Device TC38x
Marking/Step (E)ES-AD, AD
Package see Data Sheet

No. 075/20

This Errata Sheet describes the deviations from the current user documentation.

Figure 1 Message buffer transfer from Message RAM to OBF

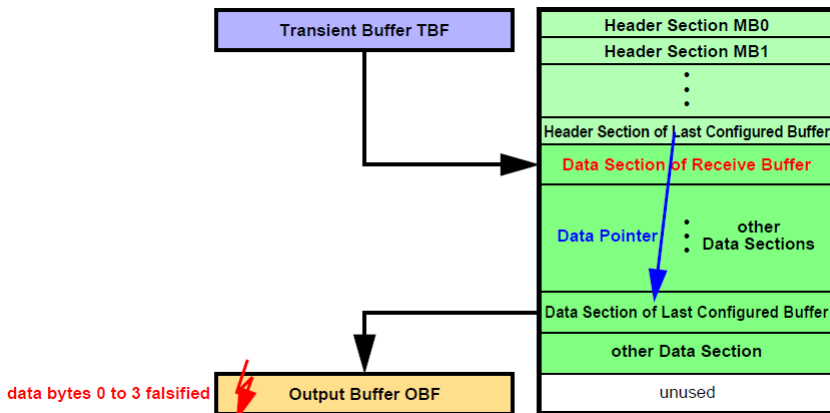
- a) Message buffer transfer from Message RAM to OBF

When the message buffer has its payload configured to maximum length (PLC = 127), the OBF word on address 00h (payload data bytes 0 to 3) is overwritten with unexpected data at the end of the transfer.

Figure 2 Message buffer transfer from IBF to Message RAM

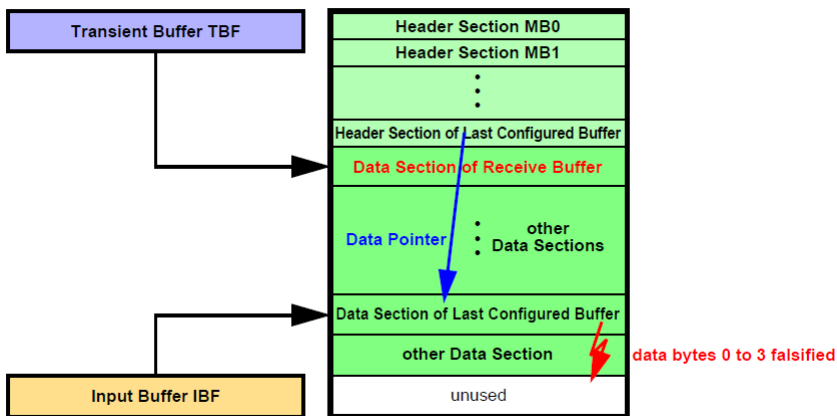
b) Message buffer transfer from IBF to Message RAM

After the Data Section of the selected message buffer in the Message RAM has been written, one additional write access overwrites the following word in the Message RAM which might be the first word of the next Data Section.

Figure 3 Message RAM Configurations

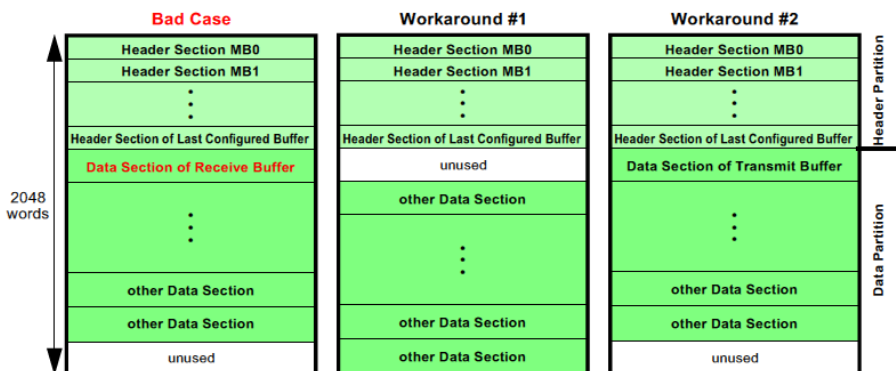
The erratum is limited to the case when (see [Figure 3](#) “Bad Case”):

- a) When a message is transferred from the Last Configured Buffer in the Message RAM to the OBF and **PLC = 127** it may happen, that at the end of the transfer the OBF word on address 00h (payload data bytes 0 to 3) is overwritten with unexpected data (see [Figure 1](#)).
- b) When a message is transferred from IBF to the Last Configured Buffer in the Message RAM, it may happen, that at the end of the transfer of the Data Section one additional write access overwrites the following word, which may be the first word of another message's Data Section in the Message RAM (see [Figure 2](#)).

2) Ensure that the Data Section directly following the Header Partition is assigned to a transmit buffer.

Figure 6 Critical MCS AEI master scenario

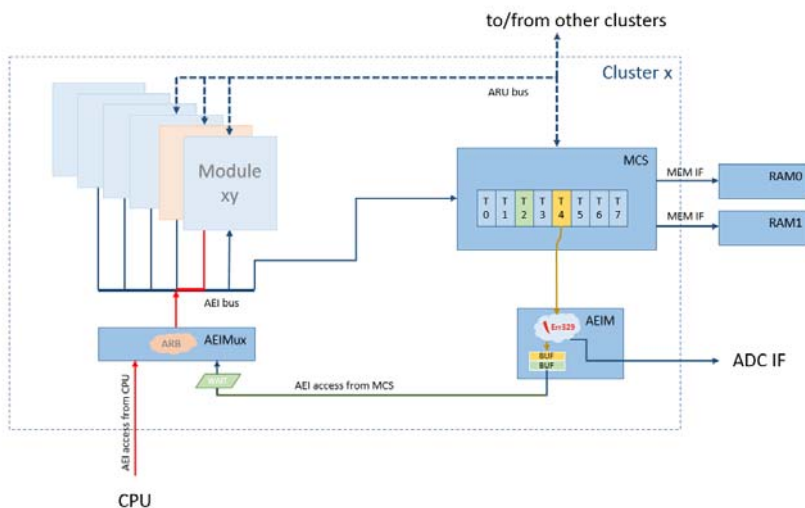
In [Figure 6](#), a potential risk for the occurrence of problem GTM_AI.329 is illustrated. Here the first buffer of the AEIM (green) is still waiting for the access to the AEI bus while a second AEI bus access from MCS arrives at the AEIM (yellow access path). Under certain, but for the user unpredictable timing conditions, this second AEI bus access arriving at the AEIM can trigger the misbehavior described in problem GTM_AI.329.

The workarounds described in the following section will ensure that not more than one AEIM buffer will be filled and therefore the occurrence of problem GTM_AI.329 is avoided. All workarounds have been tested and proven correct.

Figure 7 MCS token mechanism

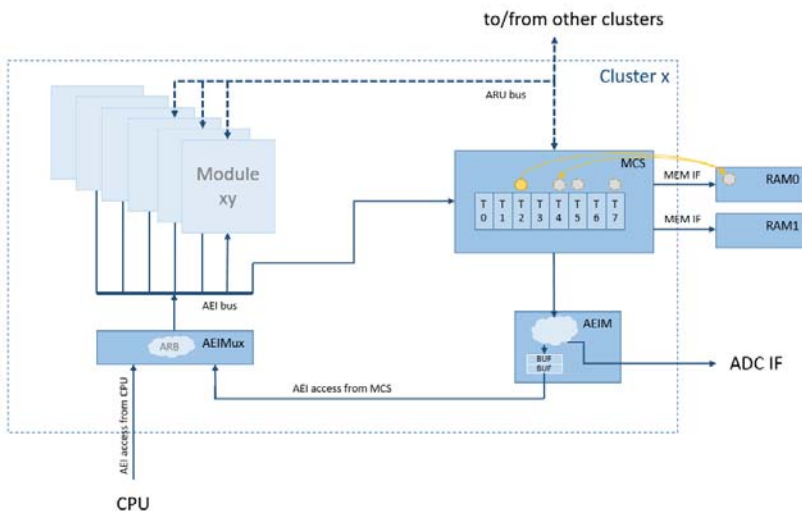
In case multiple MCS channels want to use the AEI master port for AEI or ADC communication, establish a mechanism that ensures that only one channel uses the AEI master at a time (e.g. exchange a token between channels or use trigger registers to hand over the AEI master port ownership between MCS channels).

An application note (AN020 – MCS Mutex implementation) describing a token exchange mechanism between MCS threads is available at Bosch. Such a token mechanism allows multiple MCS threads to safely access the AEI bus system by exchanging an AEI bus access token via MCS memory.

Figure 8 Equivalent Circuitry for Analog Inputs

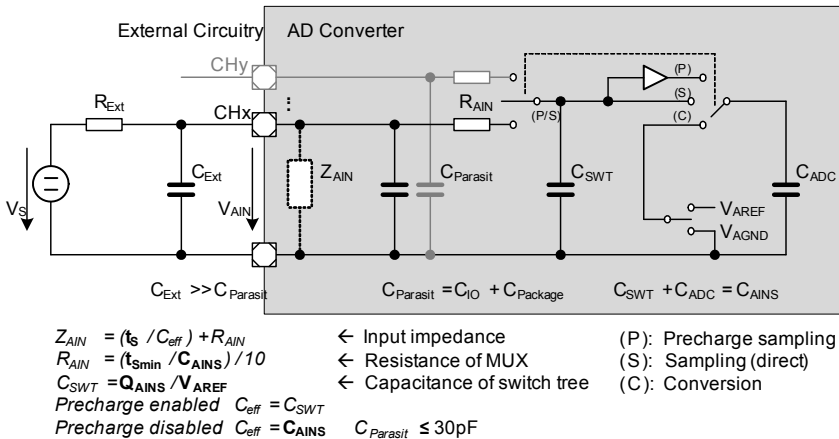
ADC_TC.P014 Equivalent Circuitry for Analog Inputs - Additional information

Figure “Equivalent Circuitry for Analog Inputs” will be modified in future revisions of the Data Sheet, including the term $C_{Parasit} \leq 30$ pF, as shown in the following figure:

Figure 9 Interrupt Level vs. Pulse-Notify mode - Corner Case Example

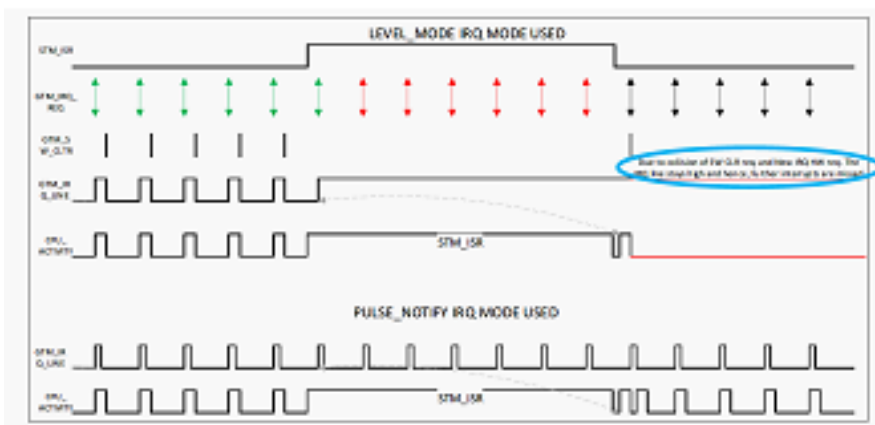
As described in the text below this figure, while using Level mode, if more internal “interrupt” events are generated (i.e. two TOM channels generating a CCU0 interrupt), just one interrupt signal is sent to the IR, and no more interrupts are triggered until the SW clears the GTM_IRQ_XXX line towards the IR.

Hence, in Level Mode, in some scenarios where another interrupt request is generated by GTM while the ISR handle also requests a SW clear, then, as the interrupt event is dominant over the clear event (for simultaneous interrupt and clear events), GTM_IRQ_XXX is not cleared and remains high. As a consequence, the IR observes no transition on GTM_IRQ_XX. Thus, any forthcoming interrupt events in this scenario are lost as there is no chance to release the CPU IRQ when a collision happens as shown in Figure below.

If Pulse-Notify mode is selected, every internal trigger will be forwarded to the IR, irrespective of the time of occurrence and the clear event, as the pulse-notify leads to set and reset of GTM_IRQ_XXX as compared to only setting of the GTM_IRQ_XXX line in Level mode.
